Application for Planning Permission Under Section 16 of the Town Planning Ordinance (Cap.131) for Proposed Flat, Shop and Service and Eating Place with Minor Relaxation of Plot Ratio and Building Height Restrictions at Yau Tong Marine Lot No.70, No.4 Tung Yuen Street, Yau Tong, Kowloon

Responses to Comments

Comments from Related Departments and Public

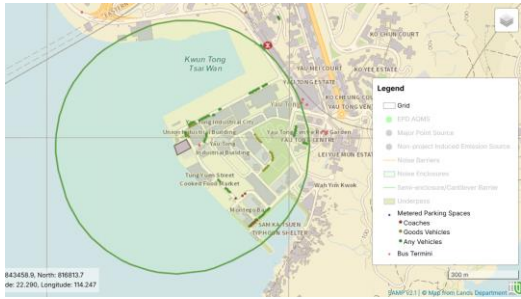
No.	Comments	Responses
	<p>10. Section 2.7: Please explain why quantitative AQIA is required for the Proposed Development.</p> <p>11. Section 2.7.3: Please supplement if desktop review from relevant approved EIA reports and/or approved planning applications has been carried out to confirm that there are no active industrial chimneys in the assessment area.</p> <p>12. Please move Section 2.7.3 to under (i) Industrial Emissions with a suitable sub-heading. Also, please incorporate Section 2.7.4 into 2.7.29 accordingly. In addition, please revise the wordings in Section 2.7.5 to state that the details of the summary in Table 2.7 are discussed in corresponding sections.</p> <p>13. Section 2.7.8: Please provide the source reference for the identification of the three concrete batching plants. Besides, please incorporate the information in Section 2.7.7 into this section accordingly.</p> <p>14. Section 2.7.12: Please include the tailpipe emissions from trucks, including their running emissions and start emissions with precious approach, associated with their movement inside the concrete batching plants.</p>	<p>As there are numerous industrial emissions (such as concrete batching plant) and marine vessels emissions identified within the 200m assessment area from the site boundary of the Application Site which cannot satisfied the buffer distance as stipulated in Table 3.1 of HKPSG Ch.9, a quantitative air quality impact assessment is therefore conducted to assess and ensure the future air sensitive receivers of the proposed development would not be under adverse air quality impact.</p> <p>As stated in Section 2.7.4 of Appendix G (renumbered), several site visits were conducted to verify the presence of chimneys and other industrial activities. It is confirmed that there is no active chimney within 500m assessment area from the site boundary of the Site upon the visits.</p> <p>Previous S2.7.3 and S2.7.4 have been moved to Section 2.7.7 and 2.7.29 of Appendix G, respectively.</p> <p>The wordings in Section 2.7.5 of Appendix G are revised.</p> <p>Reference is made to Hong Kong Environmental Database - SP licence search (https://sp-license.odensystems.net/SS), one concrete batching plant, Redland Concrete Limited, is recorded within 500m radius of the Application Site.</p> <p>Based on on-site observations, there were no terminating trucks inside the concrete batching plant (CBP) and the peak hourly flow of mixer trucks (Heavy Good Vehicle>24t) within Redland Concrete Ltd Haul Road were 17 trucks.</p> <p>For the concerned emission from mixer trucks inside the CBP, the observed peak hourly flow of mixer trucks (17 trucks) were assumed in each operation hour and adopted in open road assessment (SAMP) during the operation period (From: 07:00 to 19:00) of Redland Concrete Ltd Concrete Batching</p>

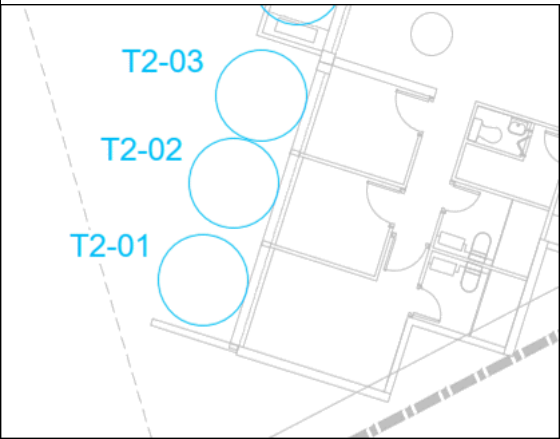
No.	Comments	Responses
	<p>advised to incorporate the site boundary onto each aerial photograph.</p> <p>(24) Appendix 5.2</p> <p>(a) To facilitate vetting and evaluate the potential for land contamination, the Consultant is advised to incorporate the site boundary into the locational plan.</p> <p>(b) The photographic records could not sufficiently show the condition of the site on the industrial buildings' ground floor. The Consultant shall carefully review the content as appropriate.</p> <p>(c) The Consultant is advised to supplement the site walkover checklist for further vetting.</p> <p>(d) Please clarify whether a site interview with the current or previous occupier was conducted.</p> <p>(25) Para. 5.9.7</p> <p>Please elaborate on the content, particularly on how the Consultant could ascertain the potential land contamination issues.</p> <p>(26) Para. 5.9.8</p> <p>The Consultant is advised to elaborate further on the information on the building plan of the Application Site acquired from the BRAVO.</p> <p>(27) Appendix 5.3</p> <p>The capture screen from BRAVO shows only the content page of the approved plan; please extract and supplement the relevant information from the plan to facilitate further vetting.</p> <p>(28) Appendix 5.4</p> <p>(a) It is spotted that the site boundary does not tally between the enquiry letter (covering the temporary structures at the south of the Godown and Figure 1.1 of this submission. The Consultant is advised to provide</p>	<p>Noted. Appendix 6.2 of Appendix F has been updated.</p> <p>Noted. Appendix 6.2 of Appendix F has been updated.</p> <p>Noted. Appendix 6.2 of Appendix F has been updated.</p> <p>Noted. Appendix 6.2 of Appendix F has been updated.</p> <p>Noted. Please refer to the para 6.2.5-6.2.7 of Appendix F.</p> <p>Noted. Appendix 6.3 of Appendix F has been updated.</p> <p>Noted. Appendix 6.3 of Appendix F has been updated.</p> <p>Noted. Appendix 6.4 of Appendix F has been updated.</p>
